Wylfa Newydd Project

Request for Non-Material Change (RfNMC) no.3

Worker Shift Patterns

17 January 2019

Figure 3-3 Proposed change to shift timings 2020

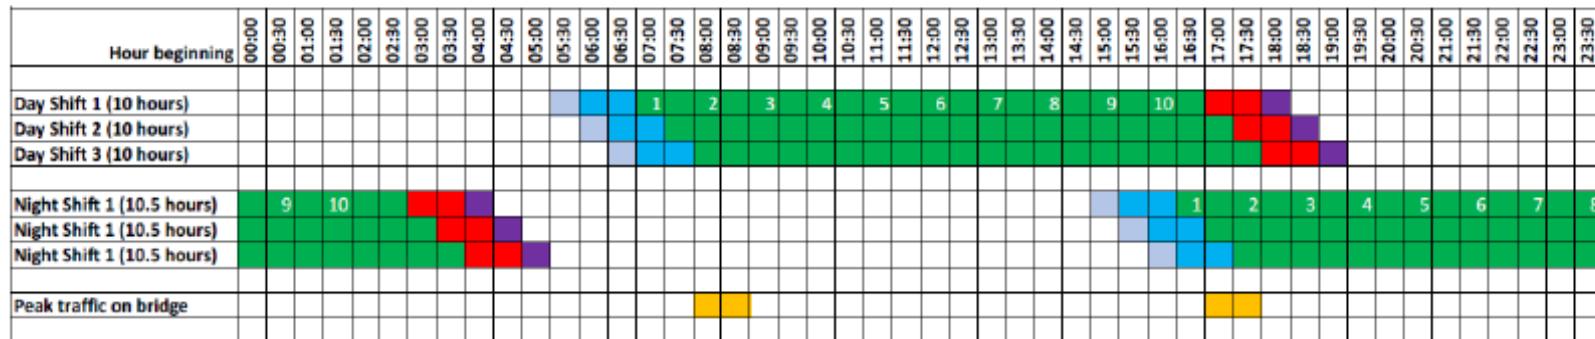
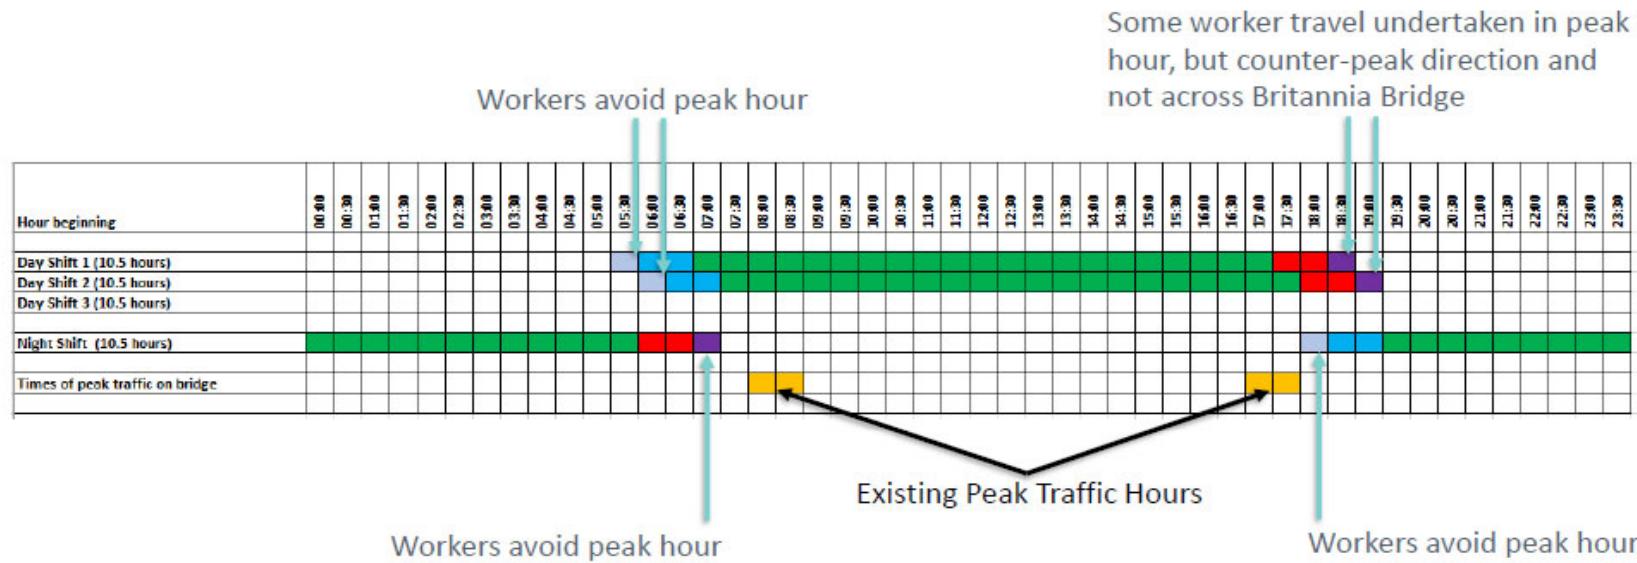
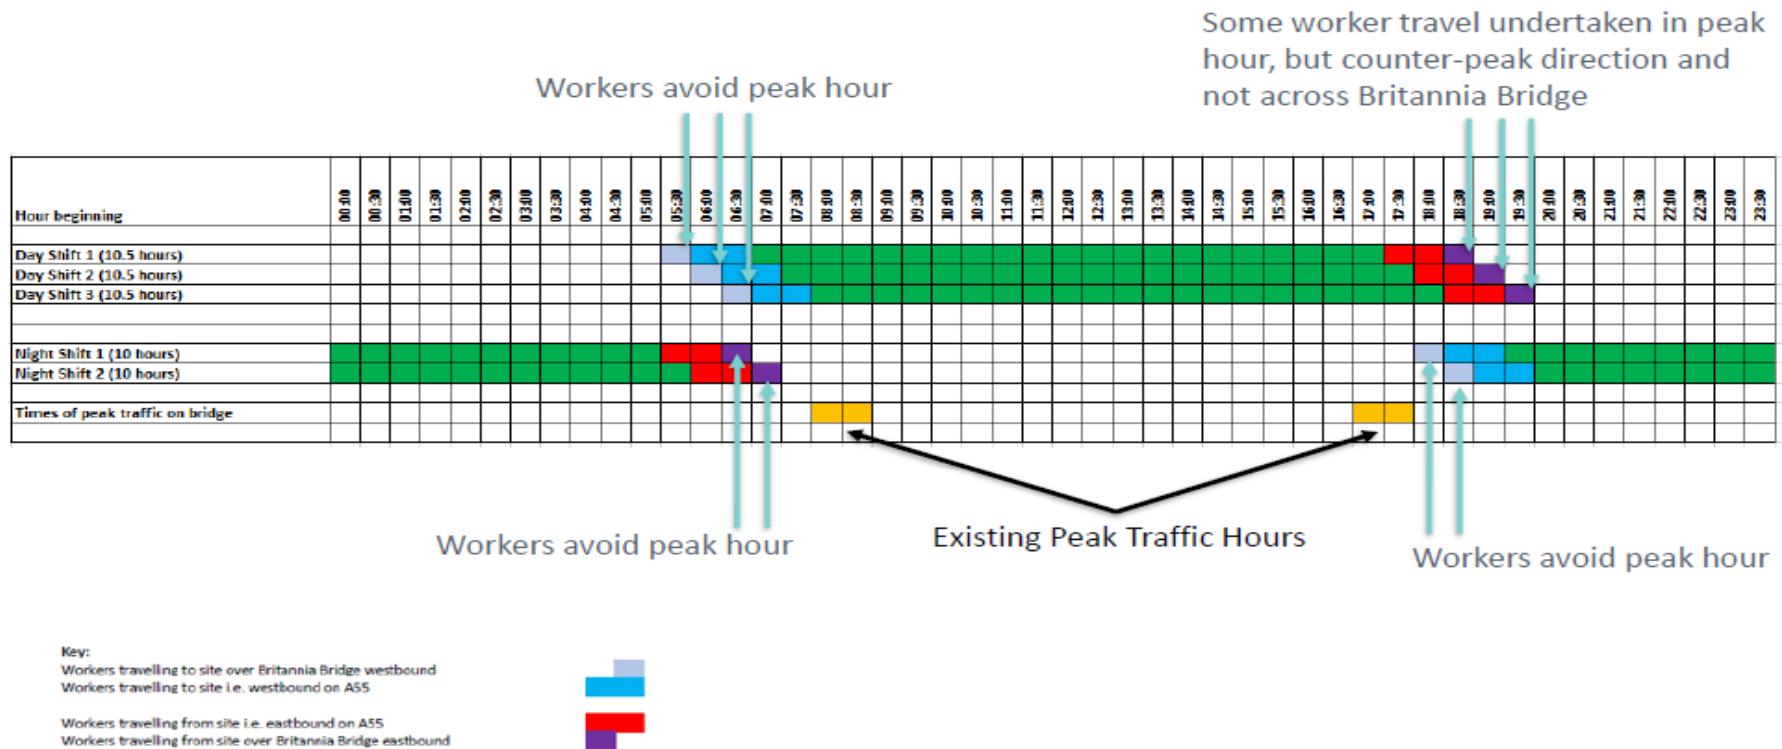
2.2.4 The proposed changes are summarised in Table 2-2 alongside the shift patterns submitted in the Draft DCO application. These are shown visually in appendix 1-2 (see figure 3-2, figure 3-3 and figure 3-4).

Shift	Primary shift start/end times/durations		
	Draft DCO application	Proposed change (2020)	Proposed change (2023)
Day	07:00-17:00	07:00-17:30	07:00-17:30
	07:30-17:30	07:30-18:00	07:30-18:00
	08:00-18:00 (i.e. 10-hour shifts)	- (i.e. 10.5-hour shifts)	08:00-18:30 (i.e. 10.5-hour shifts)
Night	16:30-03:00	19:30-06:00	19:30-05:30
	17:00-03:30	-	20:00-06:00
	17:30-04:00 (i.e. 10.5-hour shifts)	- (i.e. 10.5-hour shifts)	- (i.e. 10-hour shifts)
